Point Beach Nuclear Plant, Units 1 and 2
Dockets 50-266 and 50-301
Renewed License Nos. DPR-24 and DPR-27

Response to Request for Additional Information
License Amendment Request 247
Spent Fuel Pool Storage Criticality Control

RESPONSE TO REQUEST FOR ADDITIONAL INFORMATION LICENSE AMENDMENT REQUEST 247 SPENT FUEL POOL STORAGE CRITICALITY CONTROL

Figure 1 - Calculated k_{eff} (44-group Cross-Section Library) vs. $H/^{235}U$

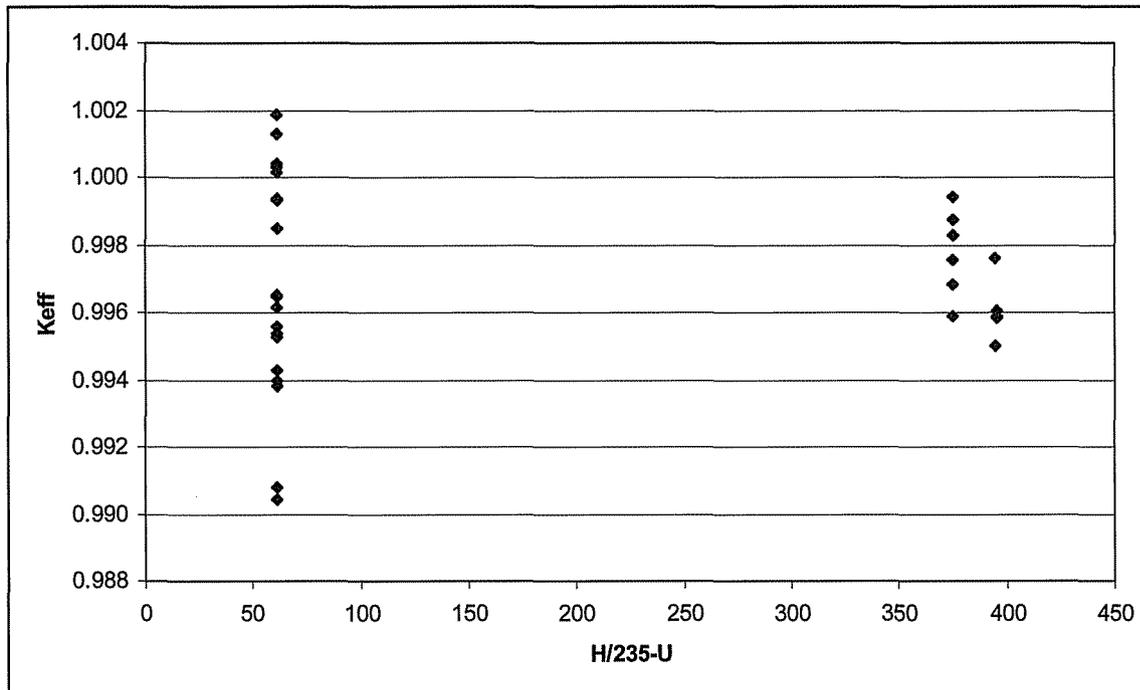
- a. Discuss and justify the method you used to select the benchmarks identified in Tables 1-1 and 1-2. For example, what parameters were considered to correlate the benchmarks to the systems being analyzed? What ranges were considered for those parameters?*
- b. Please provide additional details characterizing the benchmarks in terms of the parameters cited in Question 1a above, or submit References 9 through 12 of WCAP-16541-P, Revision 2. Currently, the submittal lacks sufficient information to evaluate the applicability of the benchmarks to the systems being analyzed.*
- c. Document and justify the area of applicability for the benchmarks.*
- d. Describe and justify any statistical and trending analyses performed to support the determination of the bias and bias uncertainty.*
- e. How did you account for the measurement uncertainties for the benchmarks?*

The calculated k_{eff} , using the 44-group cross-section library, of each of the thirty benchmark experiments was plotted versus the $H/^{235}U$ value of the experiment, and is shown in Figure 1.

The data is well distributed and no trend is apparent as a function of $H/^{235}U$. The results using the 238-group cross-section library showed similar distributions.

Figure 3 - Δk in the All-Cell Configuration

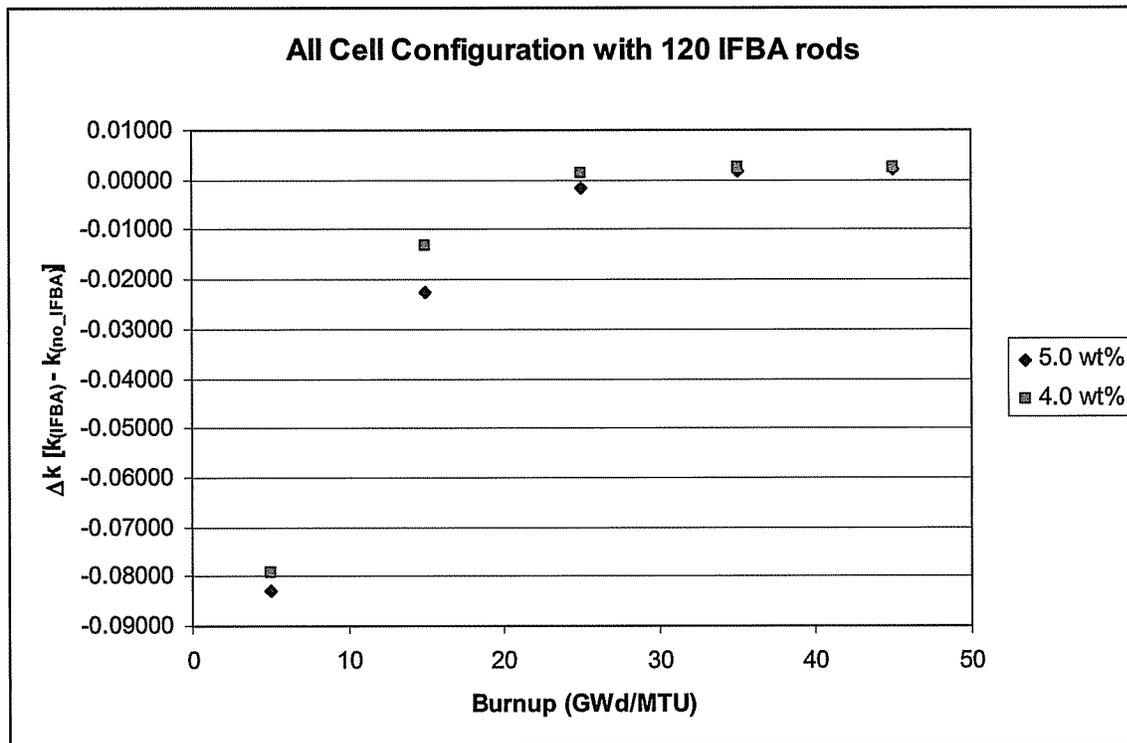
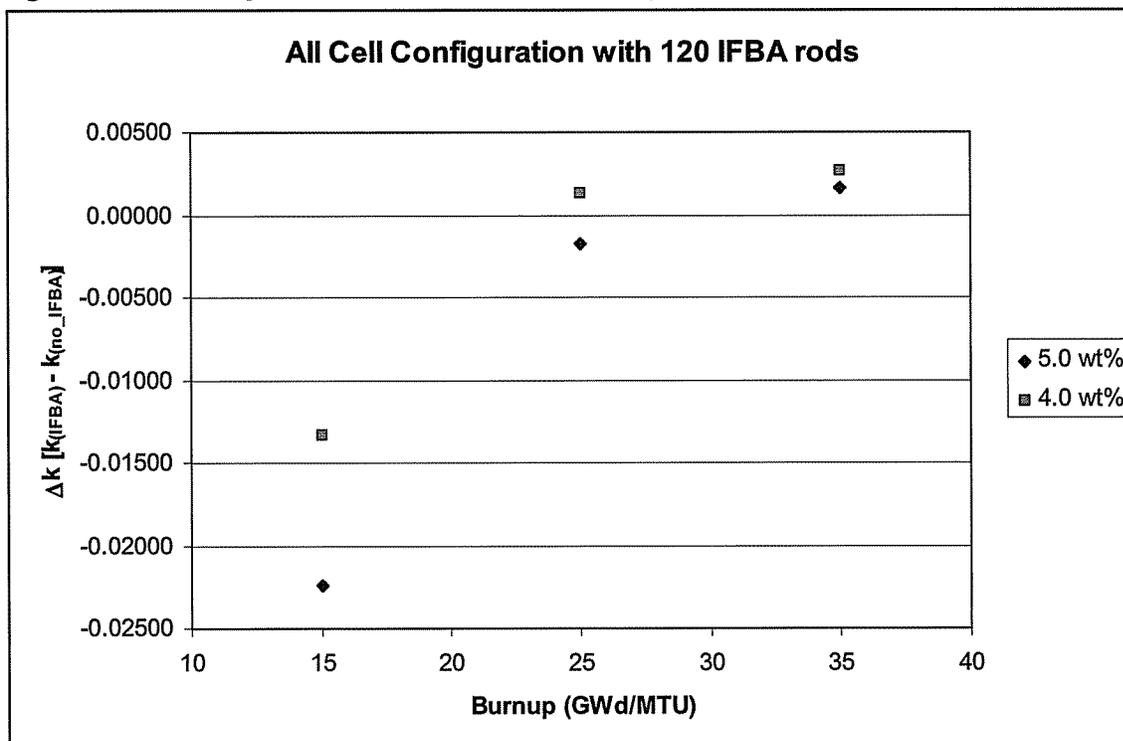
- a) *Letter dated September 19, 2008 (ADAMS Accession No. ML082630114), provided a response to the staff acceptance review. You state in response to Question 4, that the "results demonstrate that including the residual ^{10}B provides sufficient reactivity margin to account for the spectral hardening caused by the presence of IFBA during the depletion." This statement conflicts with NUREG/CR-6760 which states that "... the Δk values become positive for fuel assembly designs containing IFBA rods but remain negative for gadolinia-bearing fuel assembly designs." NUREG/CR-6760 further states that "... analyses show that there is a negative residual effect for gadolinia-bearing fuel but no such effect for fuel designs with IFBA rods." Please resolve the difference in conclusions between your analysis and that of NUREG/CR-6760.*

Some similar trends are seen between the two analyses. Figure 41 in Section 3 of NUREG/CR-6760 shows Δk values versus burnup for the 156 IFBA pattern, with varying ²³⁵U enrichments. Table 8 below shows similar trends for the 120 IFBA pattern, with varying ²³⁵U enrichments in the All-Cell configuration of the PBNP analysis. The values shown in this table are plotted in Figures 3 and 4.

The data was fit using a fifth order polynomial and the difference in eigenvalues was found for the All-Cell configuration burnup limits for 4.0 wt% and 5.0 wt%, reported in Table 4-1 of WCAP-16541-P, Revision 2. The difference in eigenvalues at the burnup limits is shown in Table 9. For this site specific analysis, at the burnup limits specified in WCAP-16541-P, Revision 2, the residual IFBA is enough to overcome the effect of spectral hardening. The results confirm that neglecting the presence of IFBA is conservative in the All-Cell storage configuration.
